# Change Notice

# M Series

## Change of Bracket Plating on Right Angle Mount M2T Toggles, M2T Rockers and M2B Pushbuttons

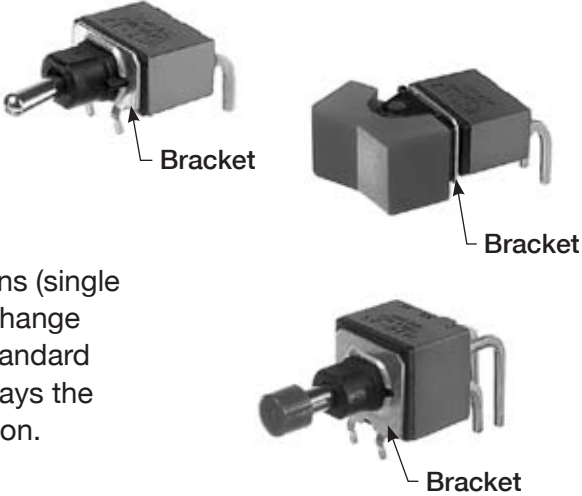
All models of M2T toggles, M2T rockers and M2B pushbuttons (single pole and double pole) with right angle mounting will have a change to the plating of the brackets. This change will effect both standard and custom products for these series. The table below displays the material of the bracket plating before and after the modification.

Plating of Right Angle Bracket	
Before Change	After Change
Tin (Sn) Plating with Copper (Cu) Alloy	Tin (Sn) Plating
Undercoat: Nickel (Ni)	Undercoat: Nickel (Ni)

There are no changes to the switches’ dimensions.  
 Contact the factory if more details are needed.
